PLANNING COMMISSION REGULAR MEETING AGENDA

Subject: 313 South Street Building Additions; Site Plan Review; Revised Plan dated 8/6/2025.

Subject: 120 S. Main Medical Office; site plan and special projects review #1; Revised Site plan and elevations dated 8/1/2025, plus supplementary information.

024148
A1.1

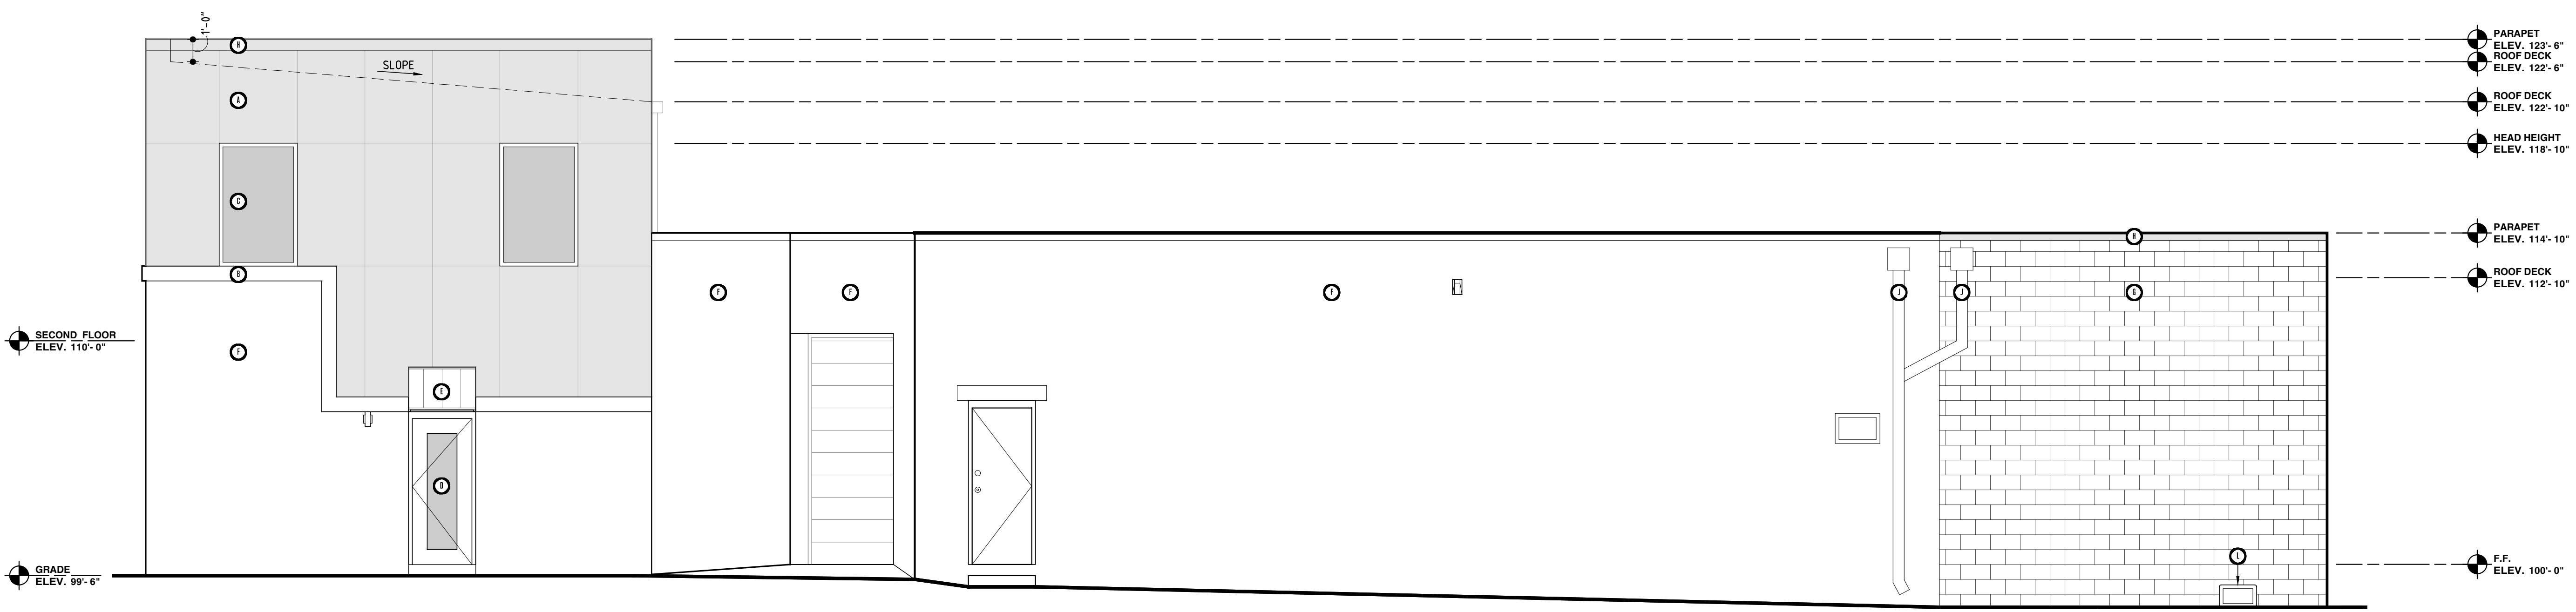
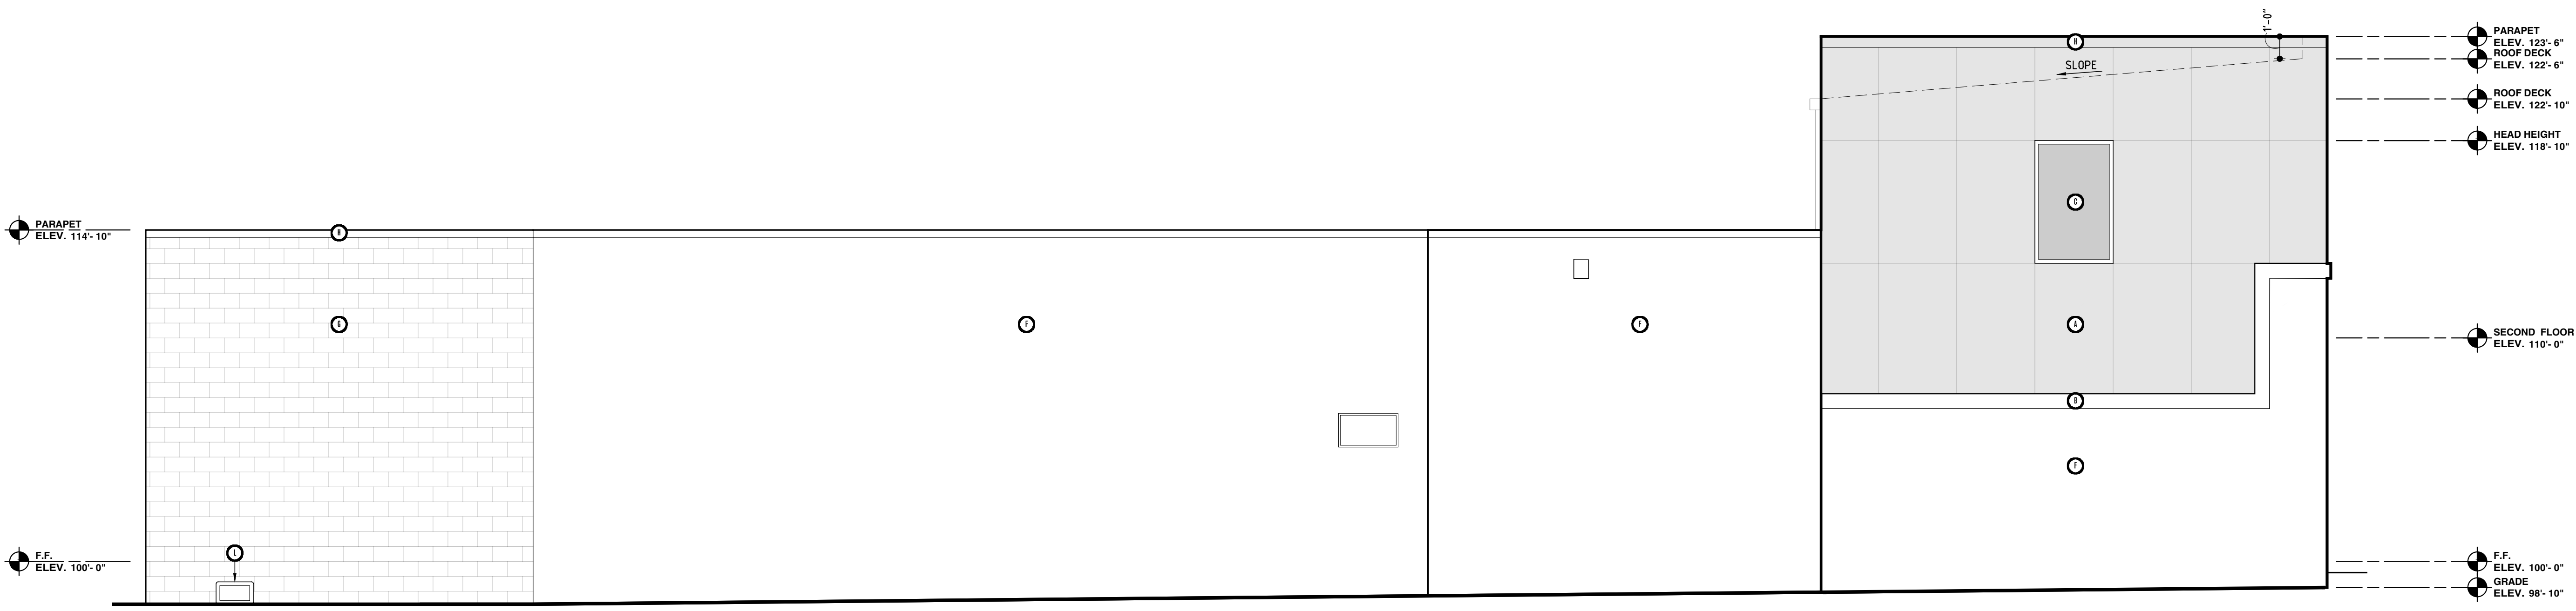
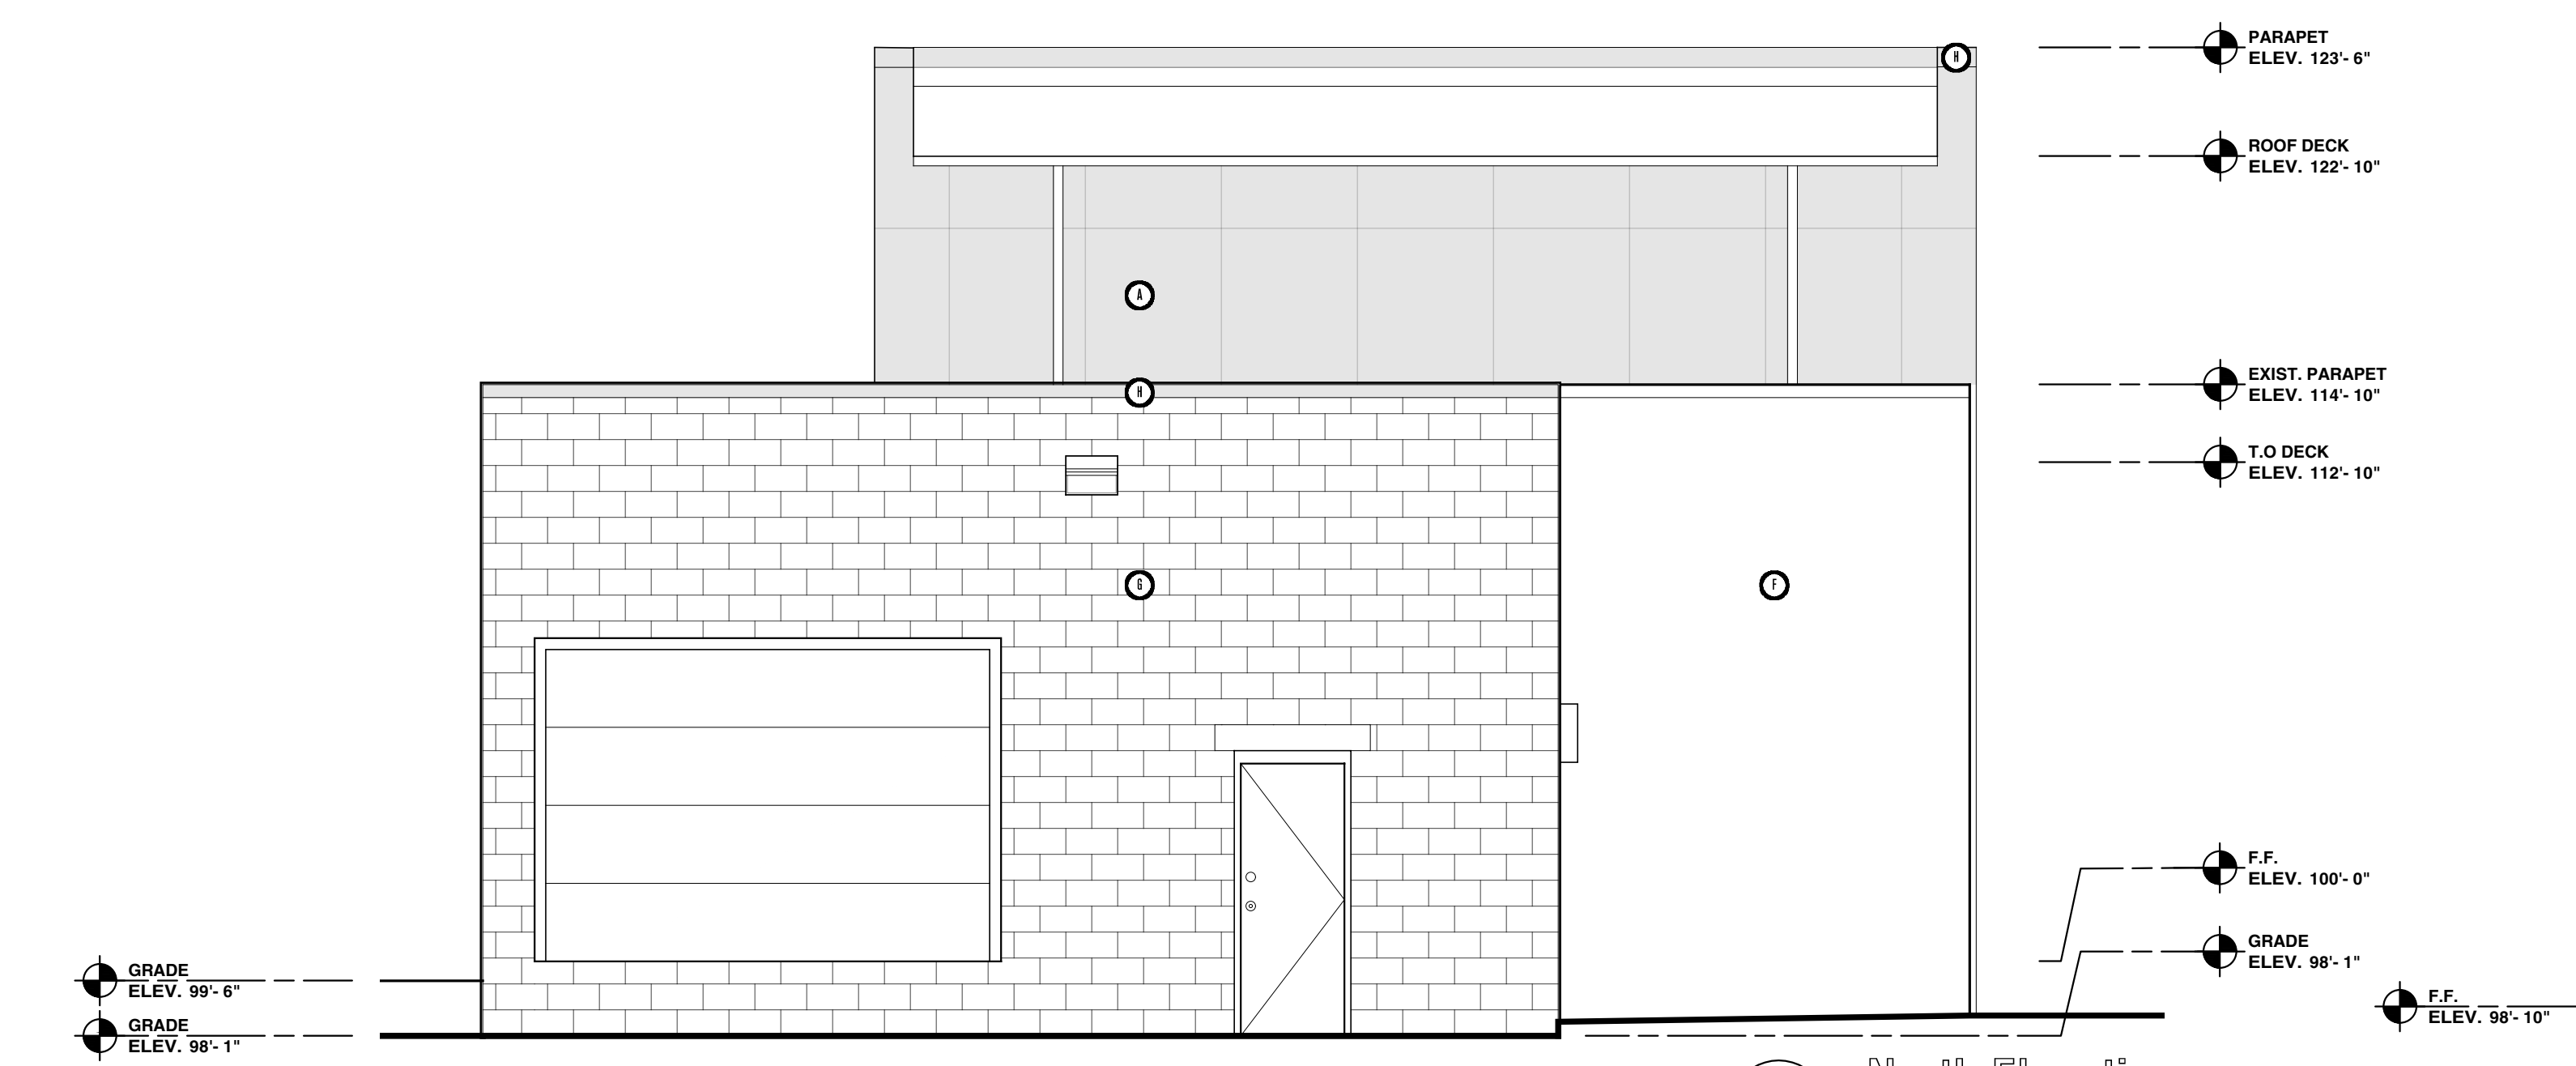
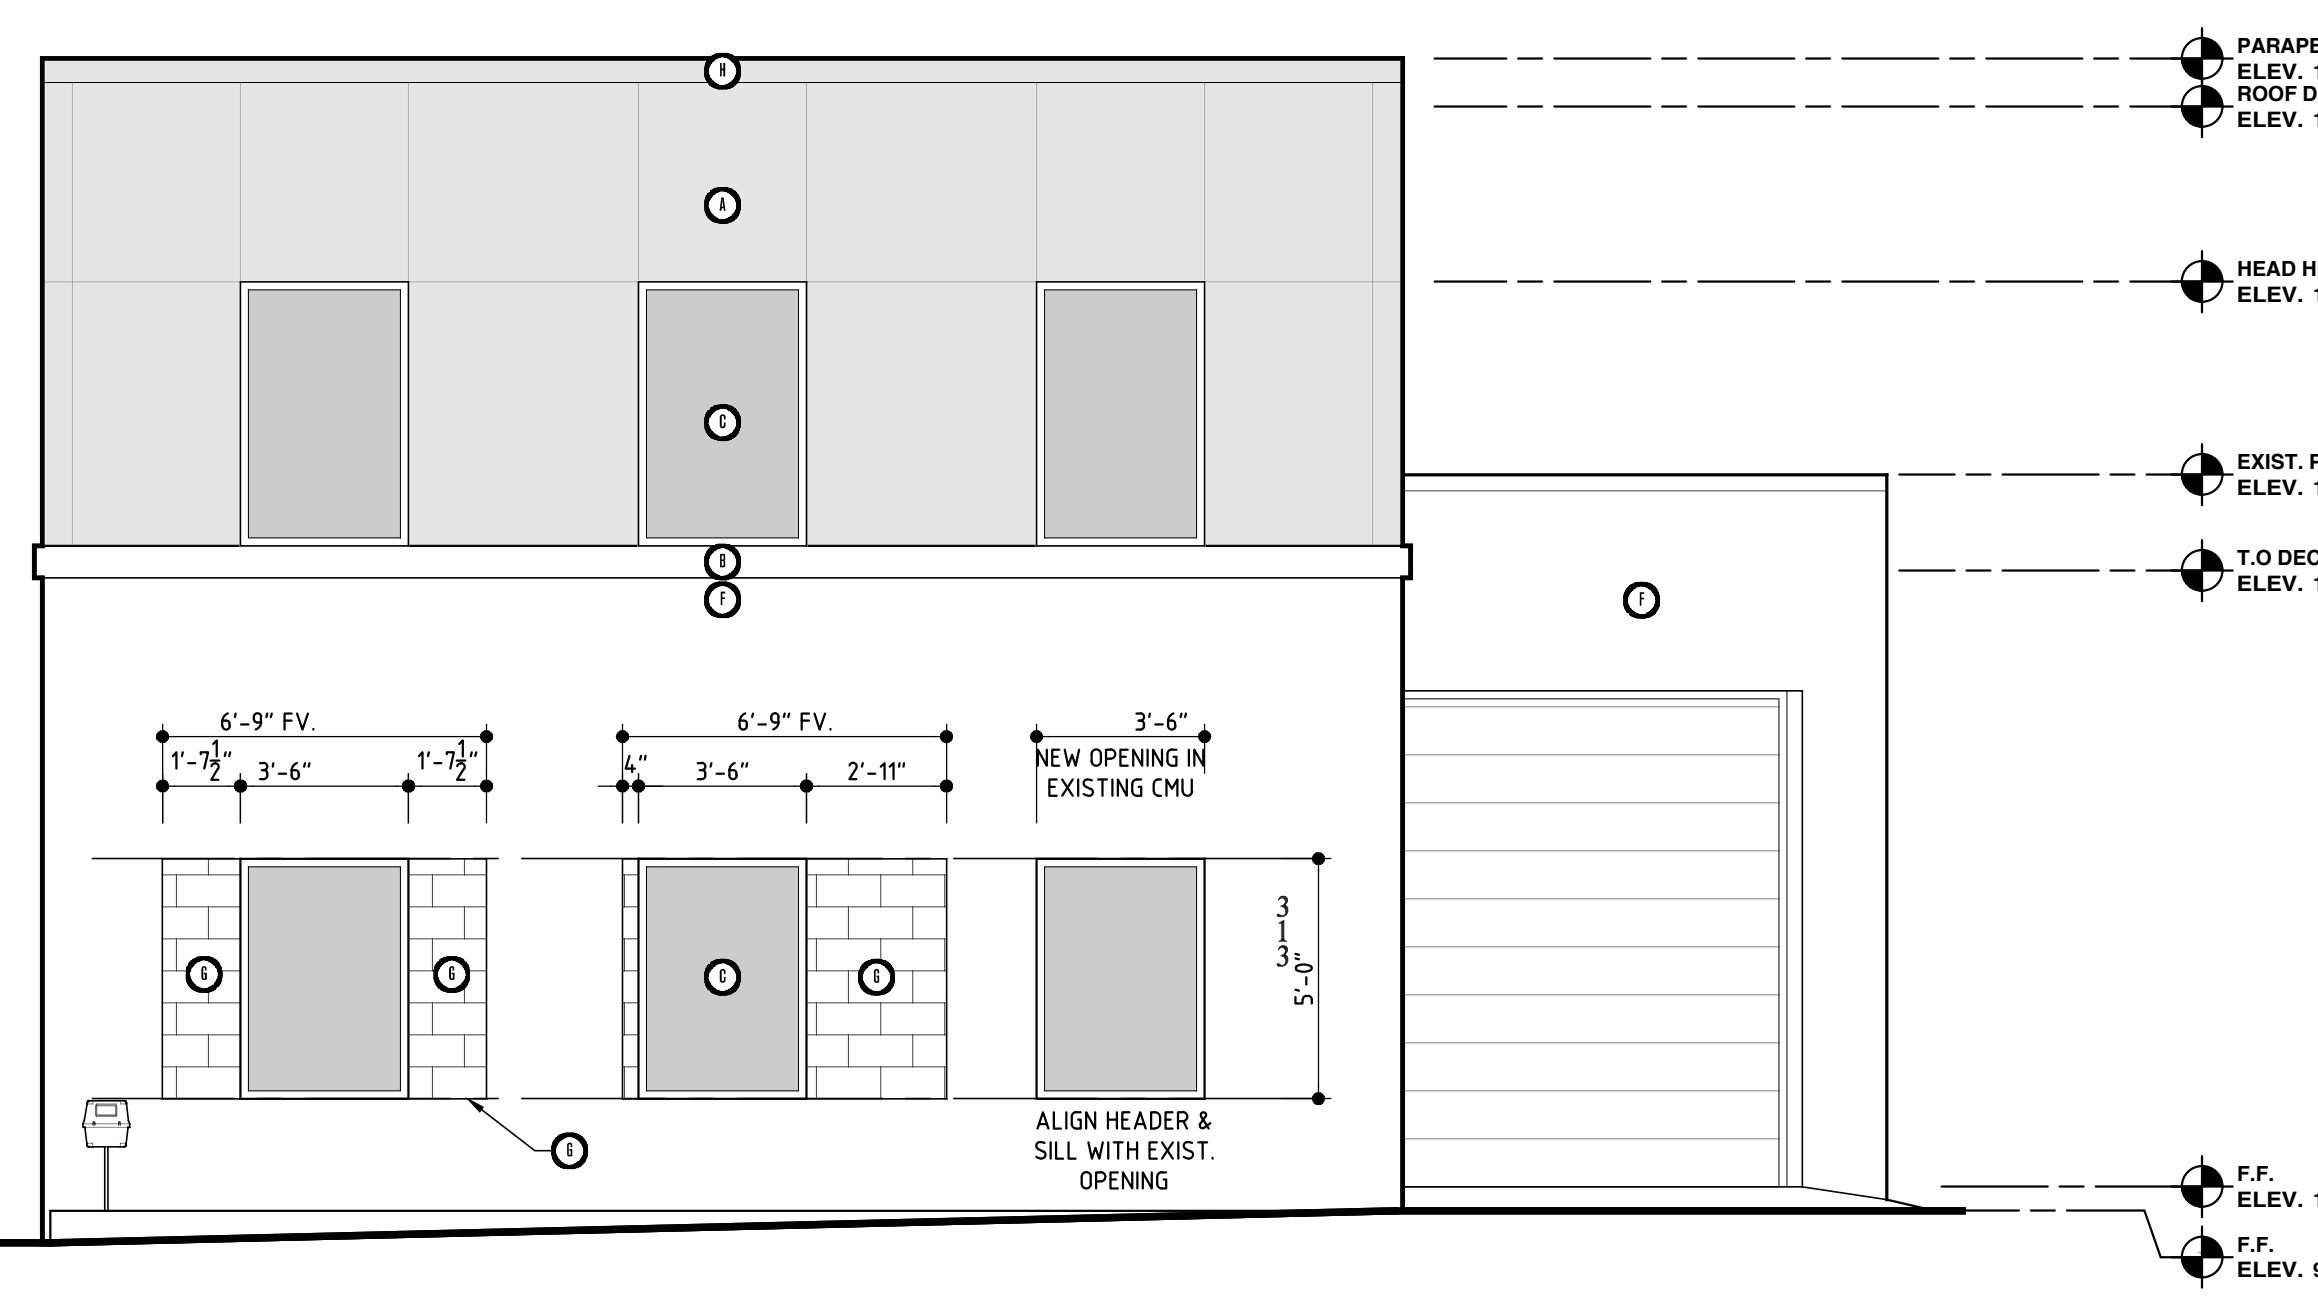
8. **Architecture.** The existing building is an old block building in need of upgrade and maintenance. The subject site is located in an area envisioned in the City's Master plan as an area of future growth for research and technology-based uses (R-TECH). Based on our previous recommendations, the elevations were revised to include staining the existing block building white and constructing the new second story addition of black metal panels with a white coping. The front façade facing south Street has windows on both levels giving it an 'office' appearance, much more consistent with the R-TECH vision for the area.

The applicant has submitted a revised colored rendering of the building on Sheet A10.1 depicting the site with landscaping.
